Town of Rolesville, NC
Department of Planning

Comments on #PSP-26-0002 - Planning & Zoning: Preliminary Subdivision Plat

Application Number: #PSP-26-0002
Application Type: Preliminary Subdivision Plat
Date: October 1, 2026
Address: 2206 Wait Ave Wake Forest NC 27587

ATTICUS WOODS

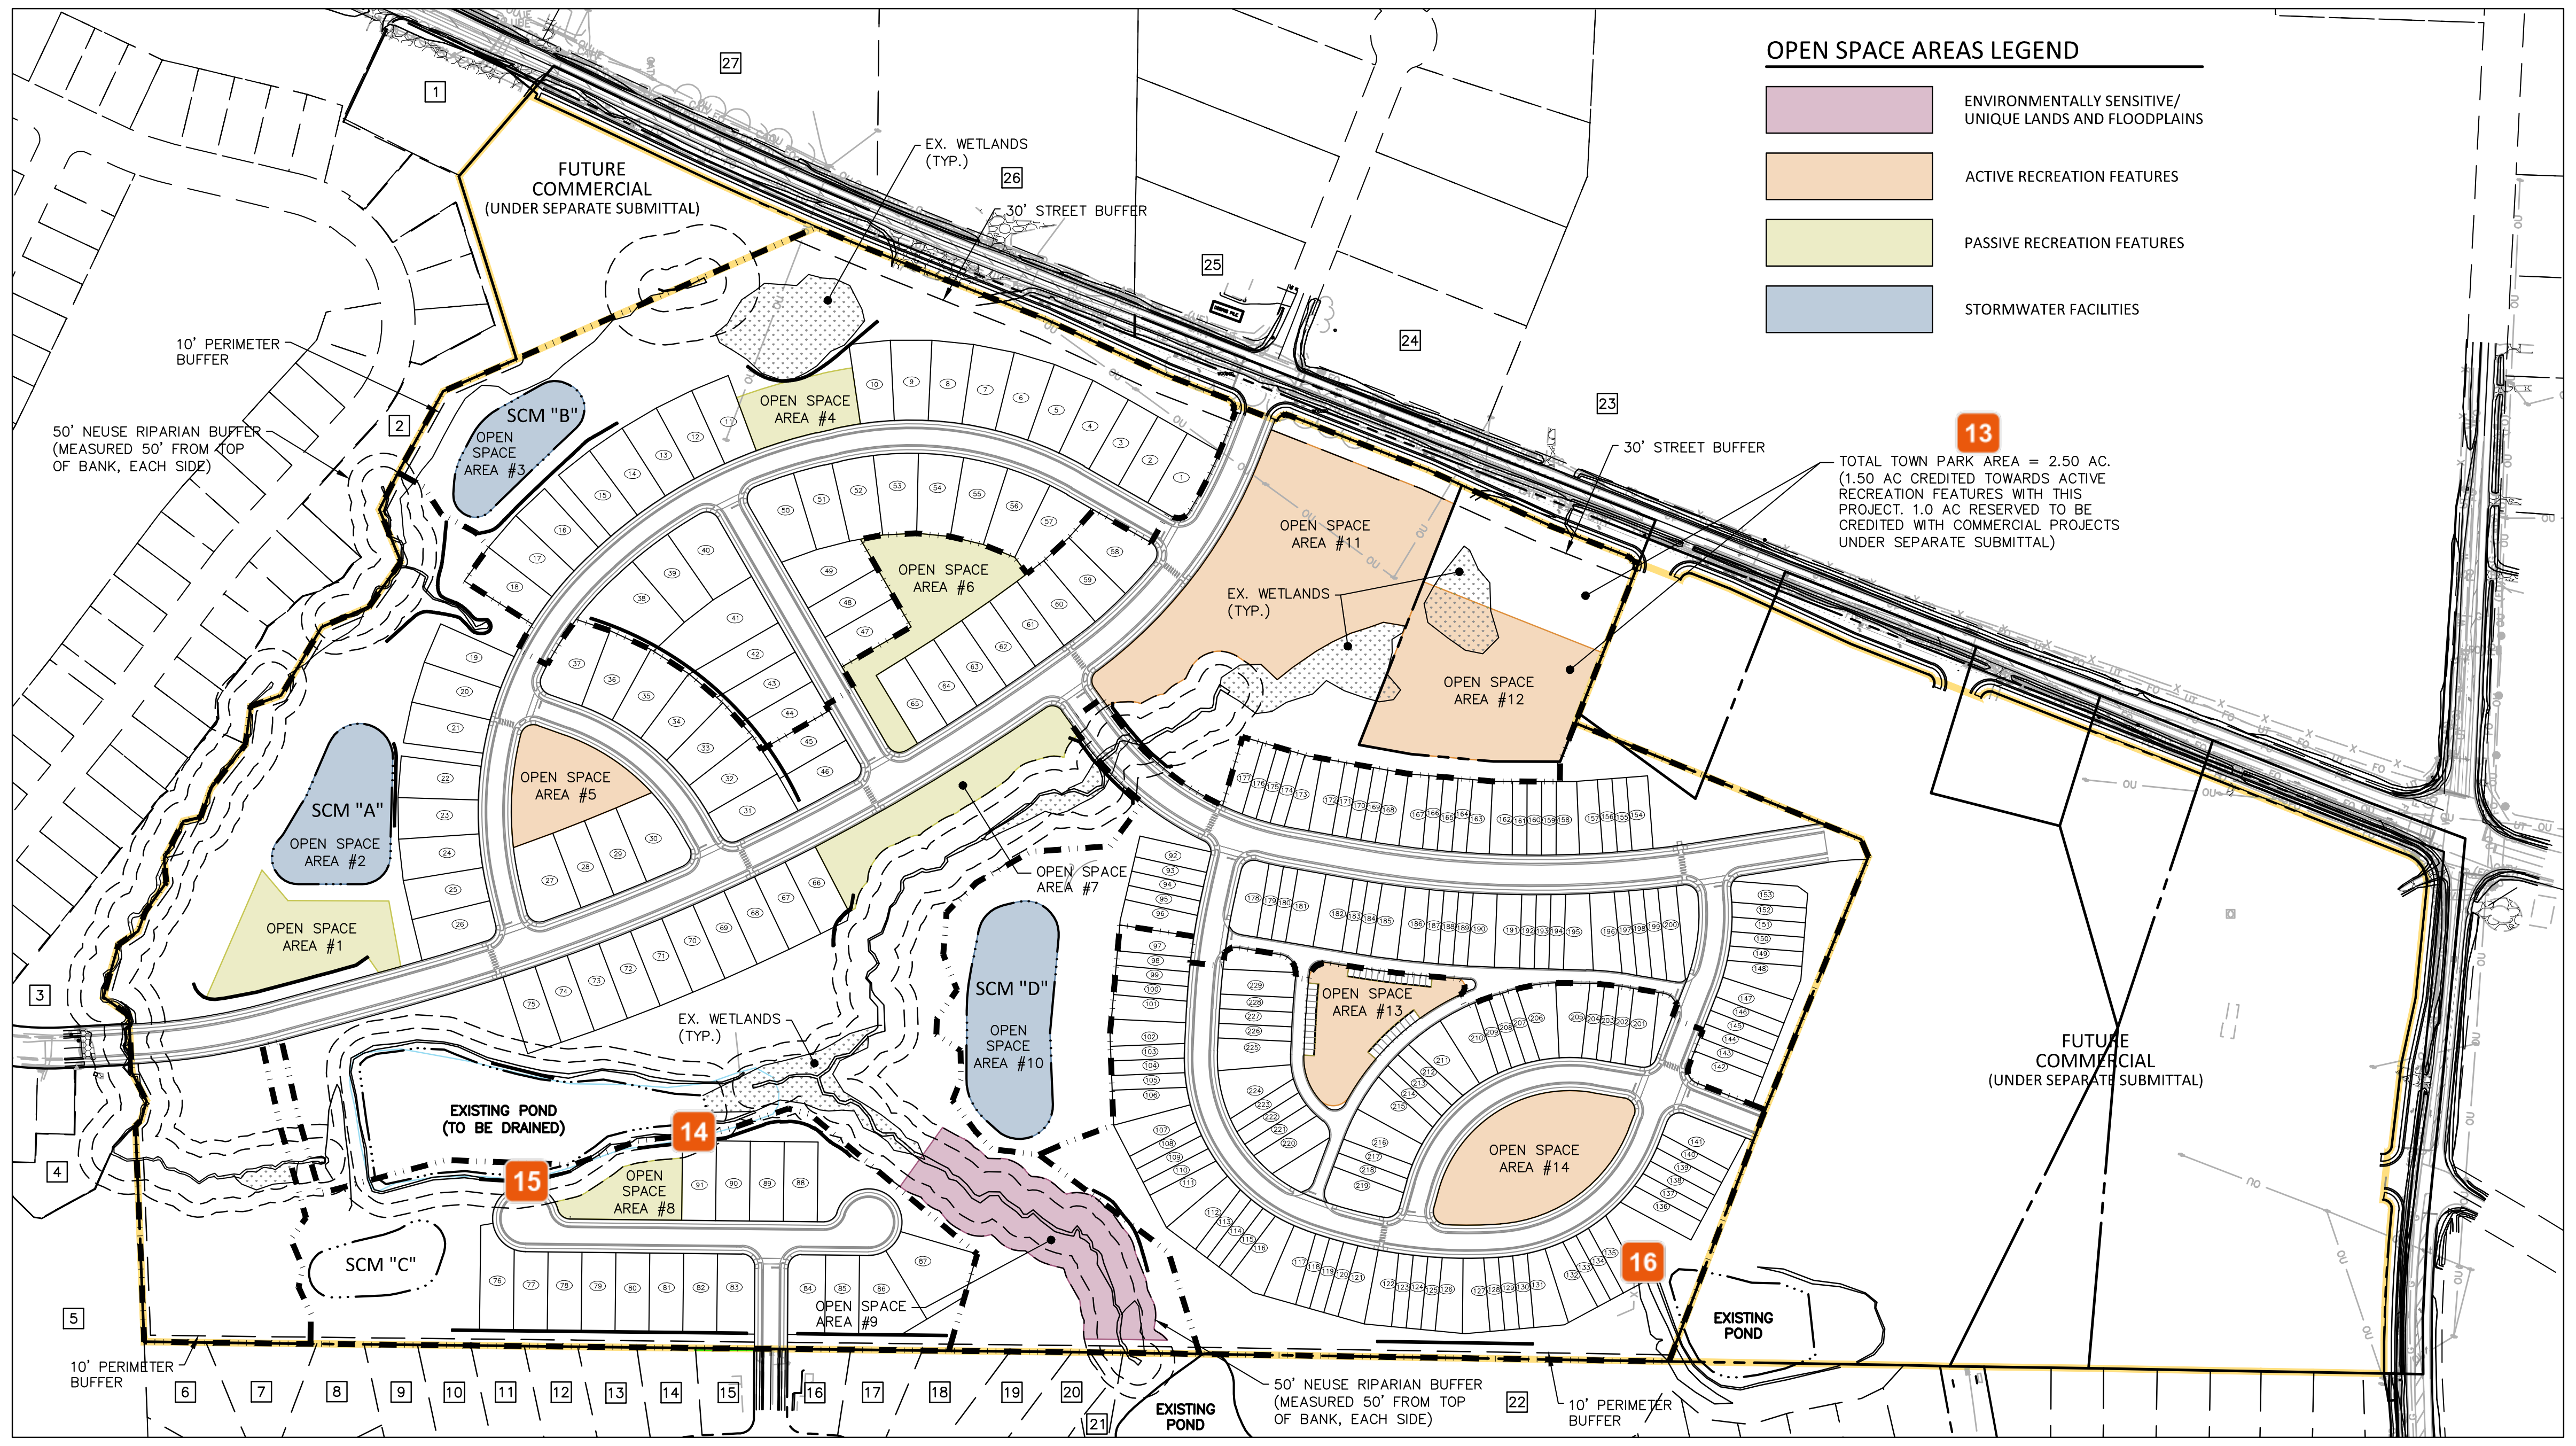
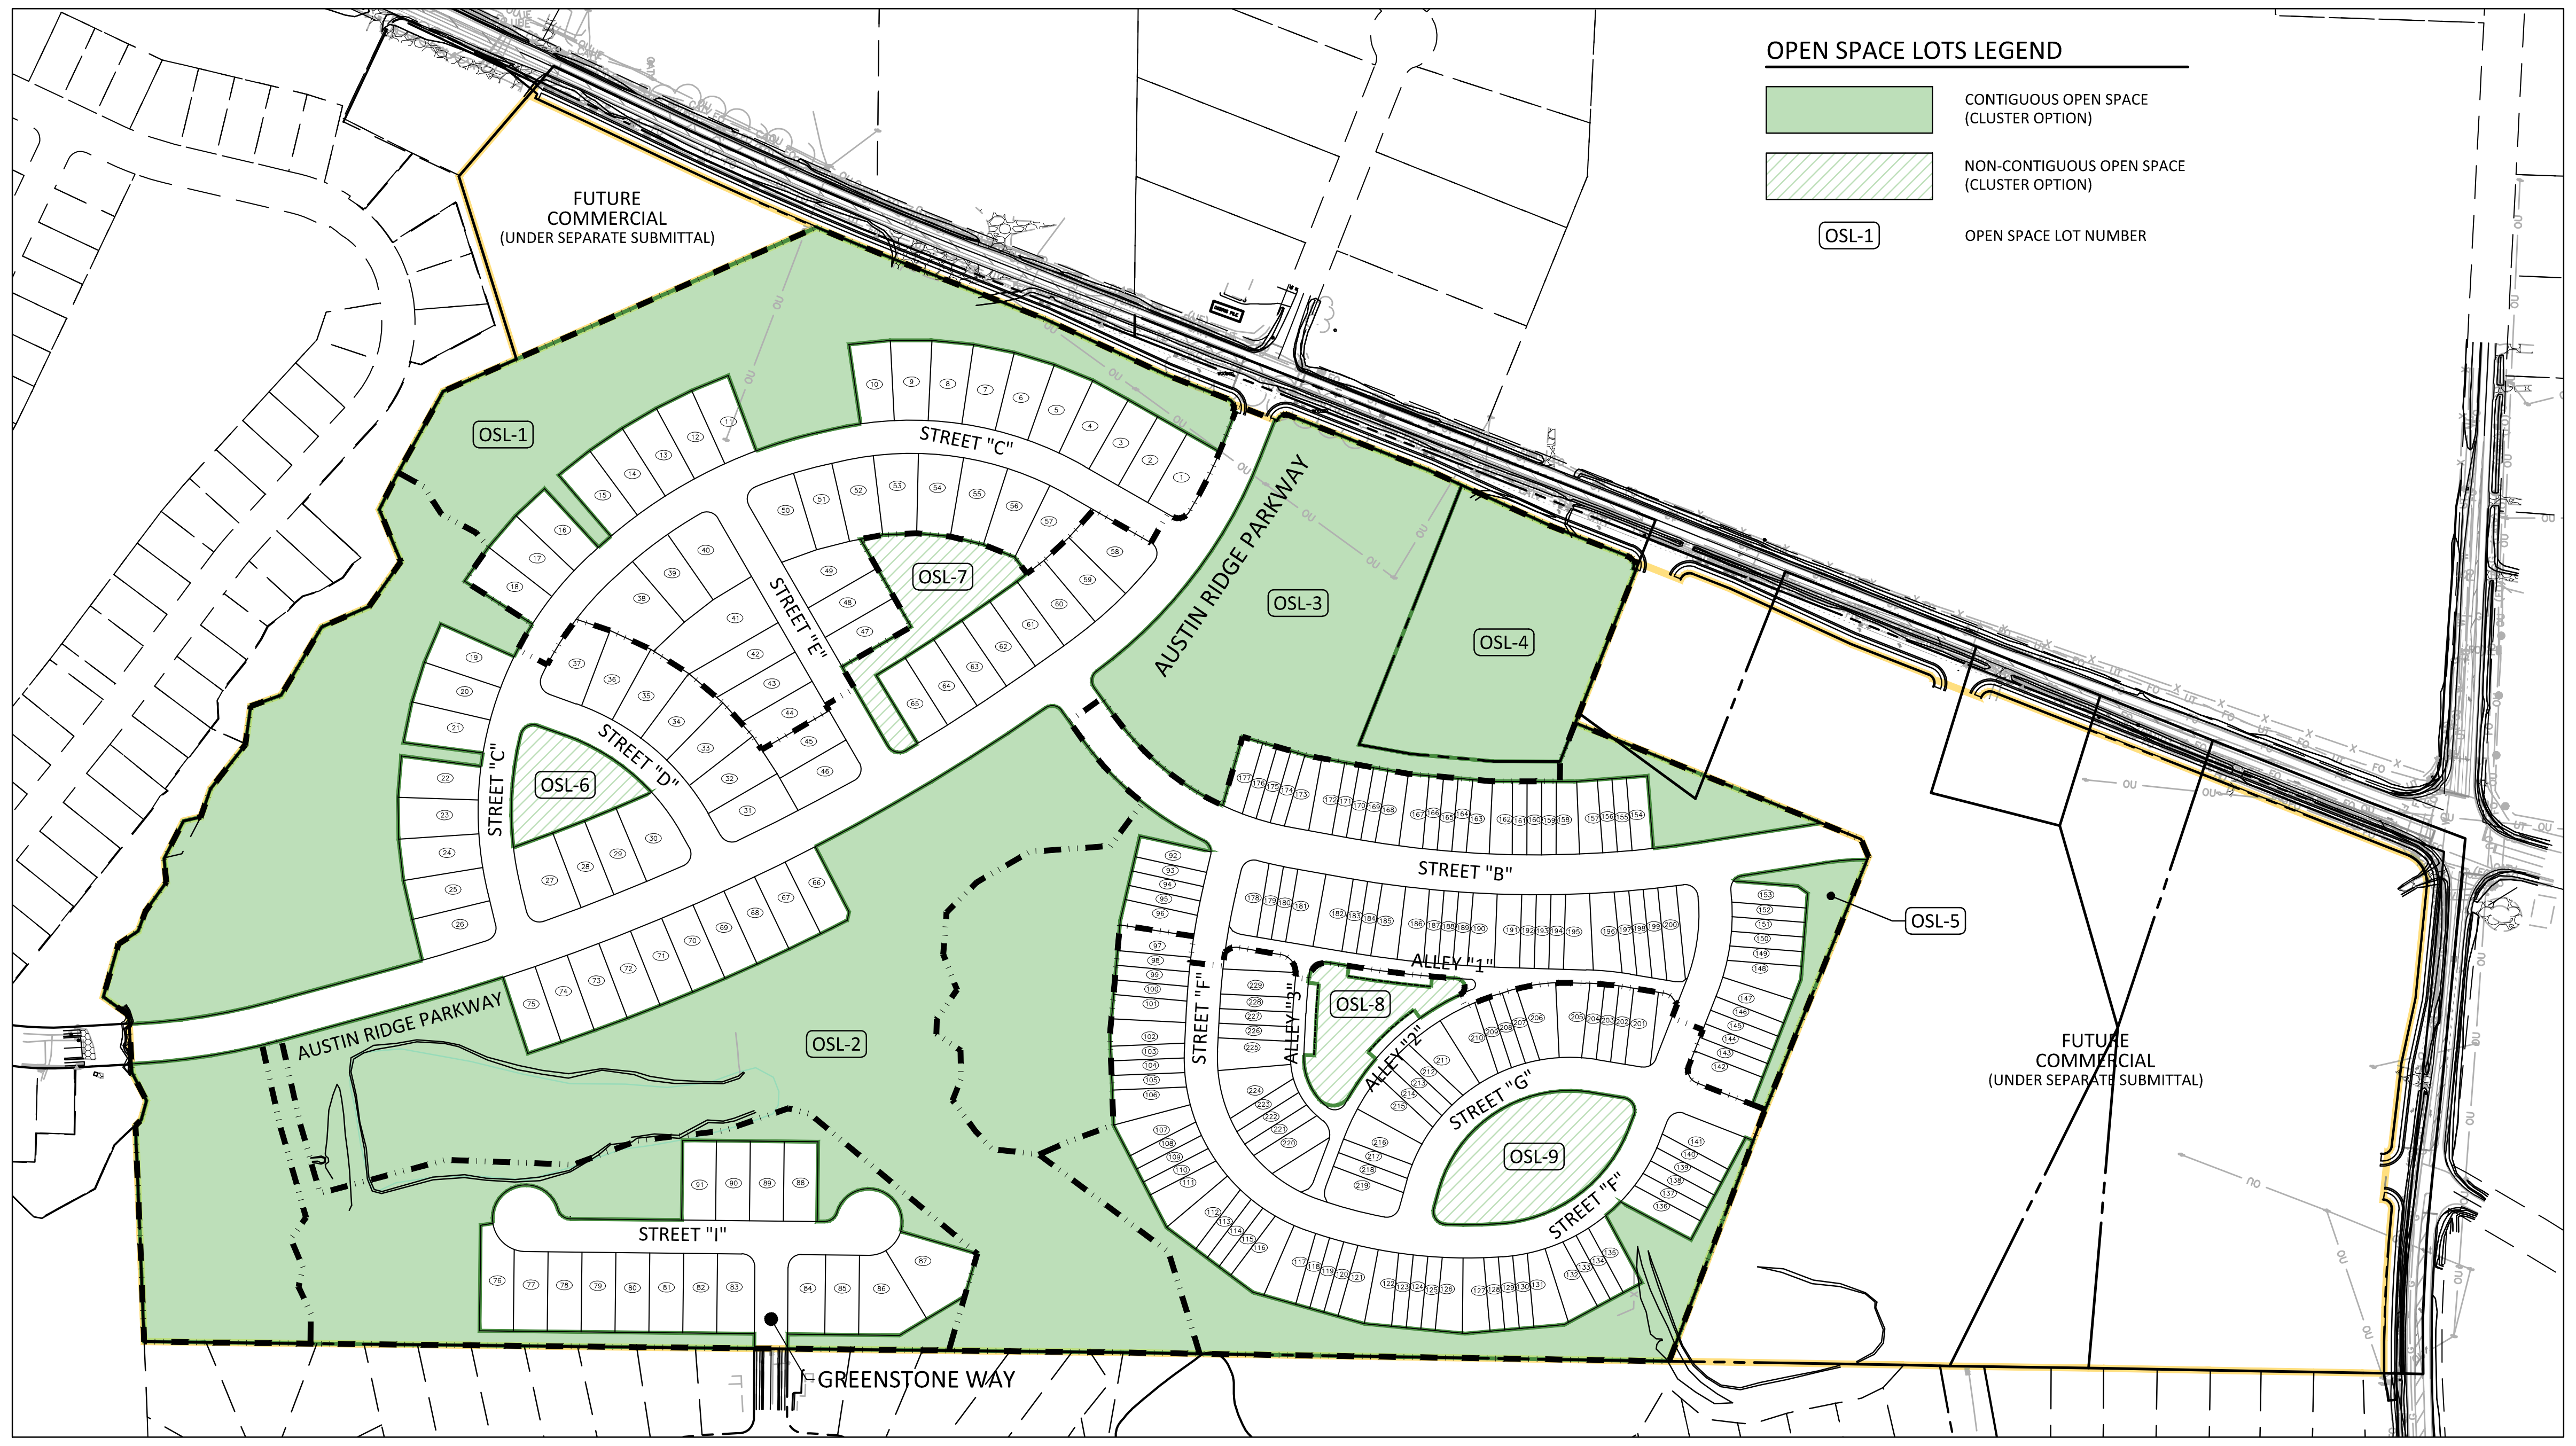
Add a note: To be dedicated to the Town of Rolesville at Final Plat.

Provide documentation that the road does not violate NCDEQ Buffer Rule.

Verify if this is riparian buffer on this lot. Riparian buffers should be outside of lot area.

16 **Stephen Wensman**
Verify if this is riparian buffer on this lot. Riparian buffers should be outside of lot area.

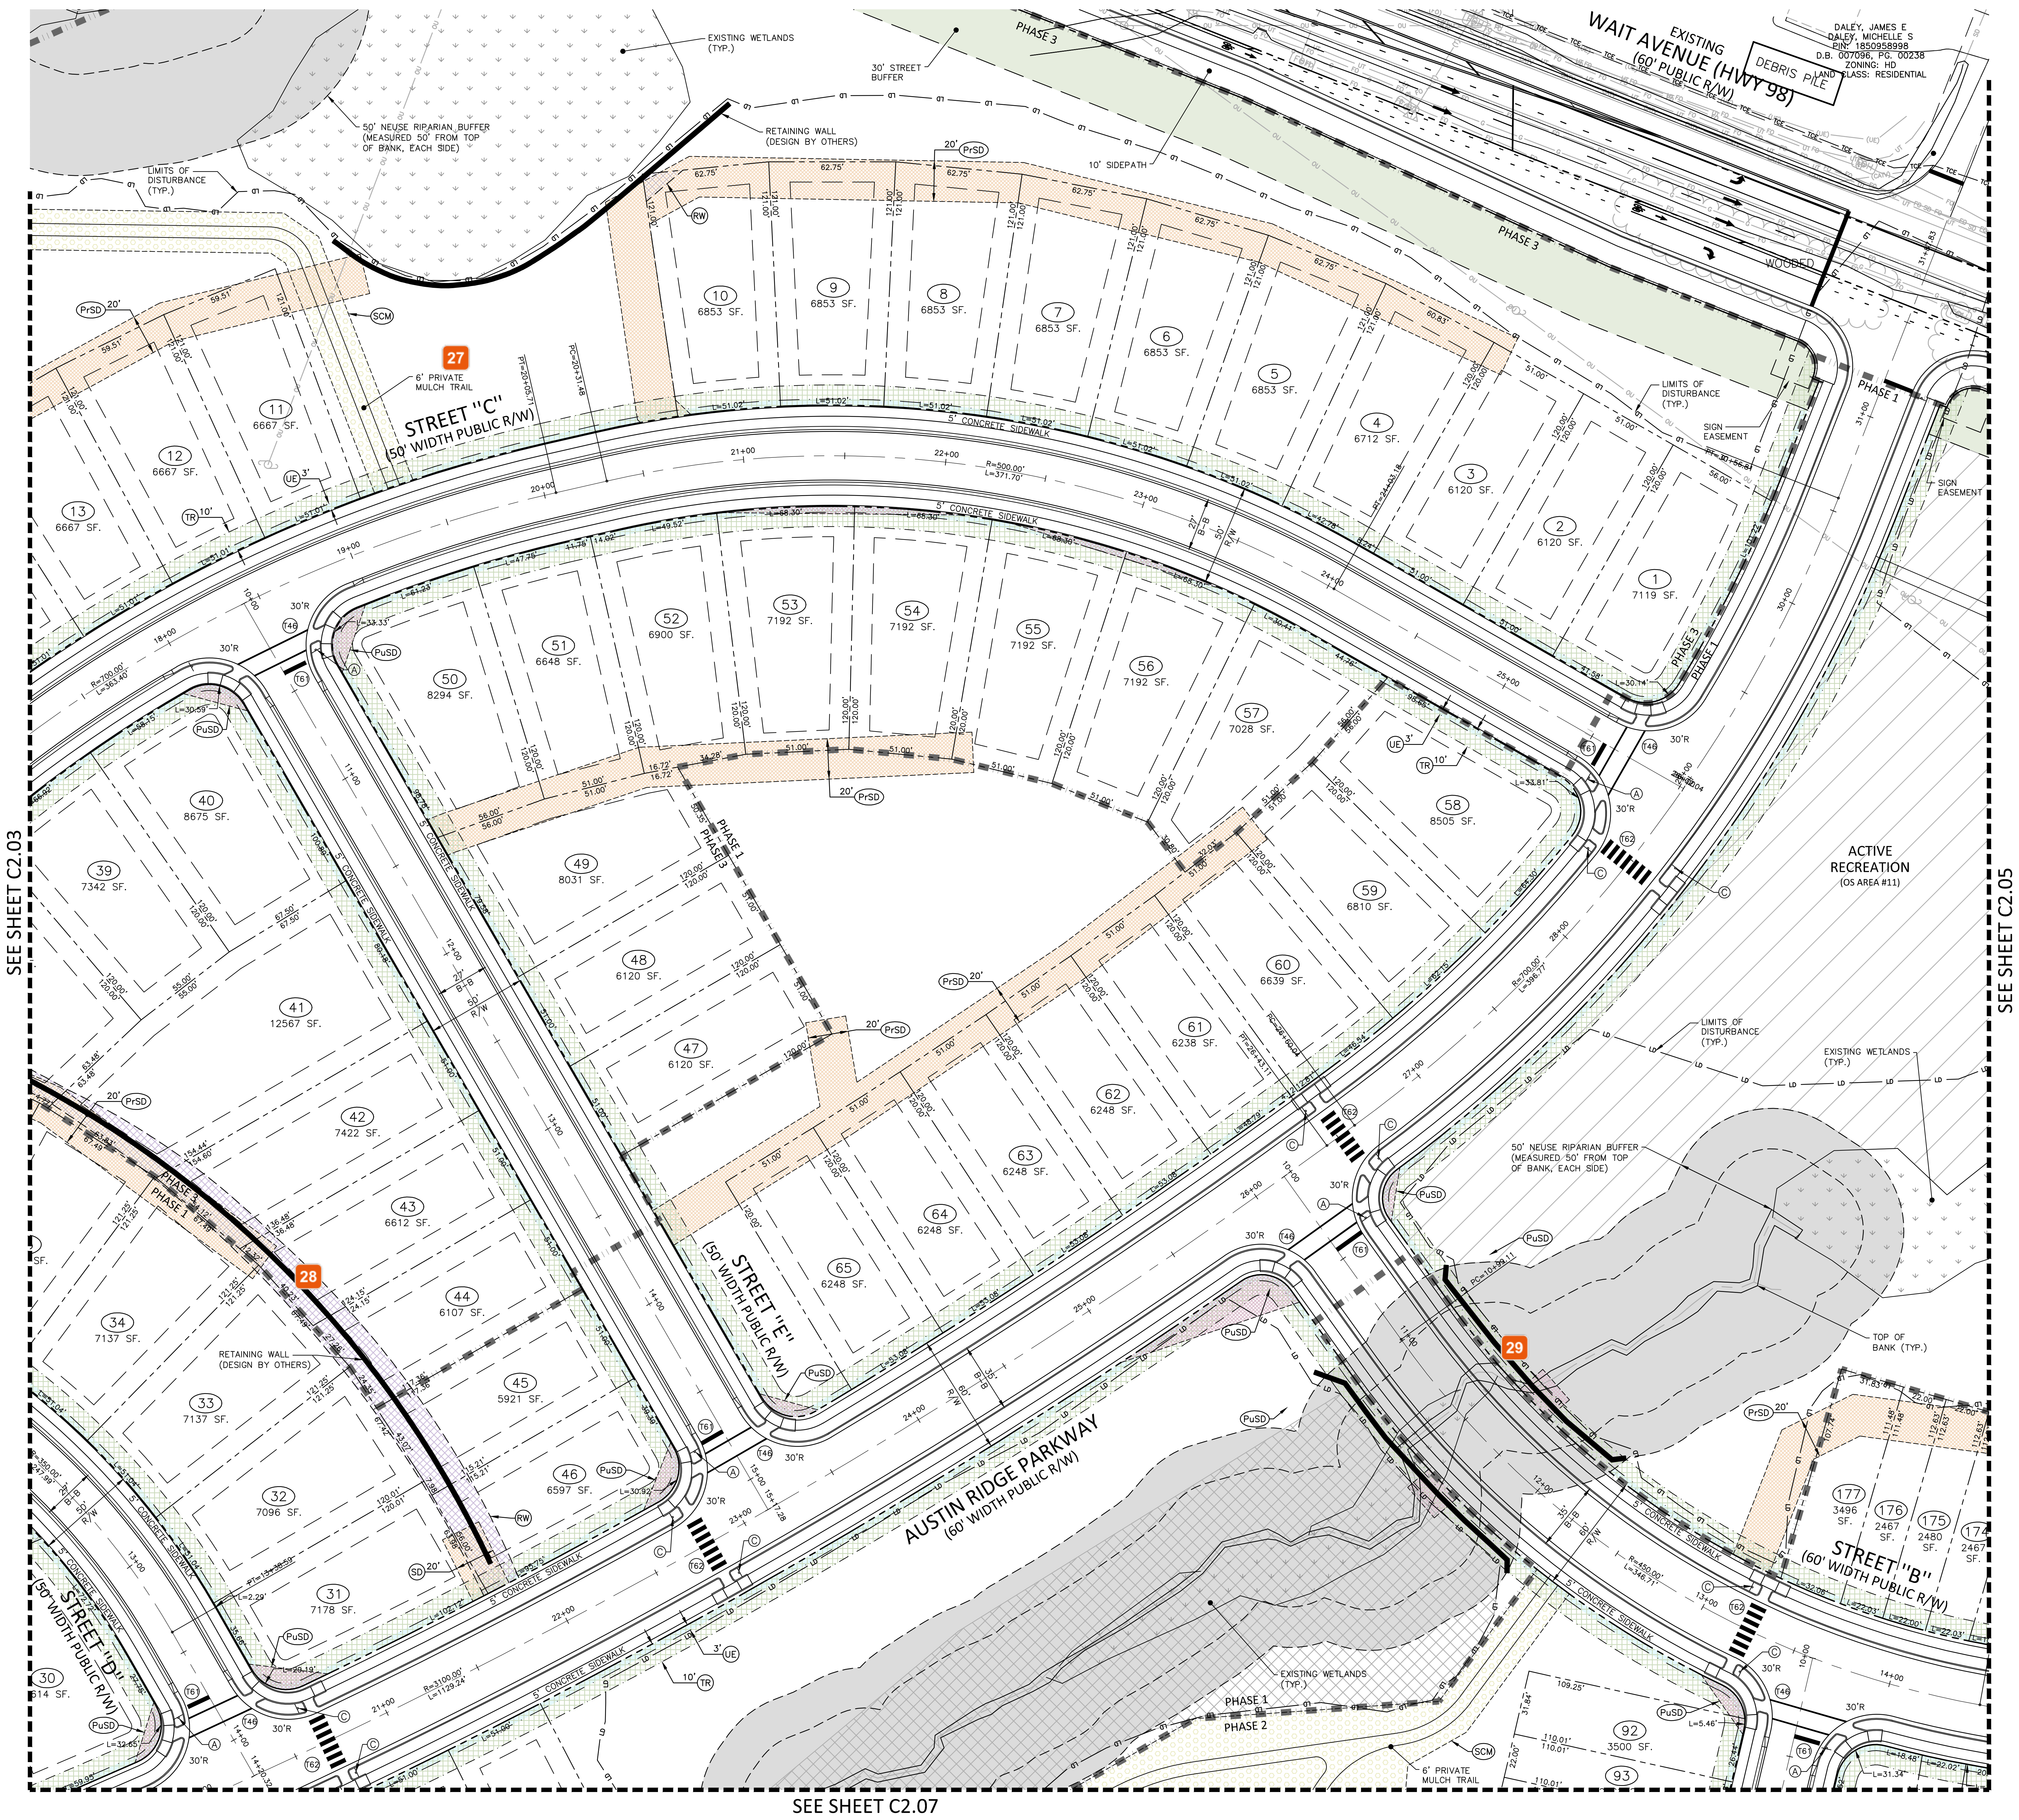
Add note: wall to be maintained by the HOA

26 **Stephen Wensman**
Tree save hatch seems impractical give the retaining wall
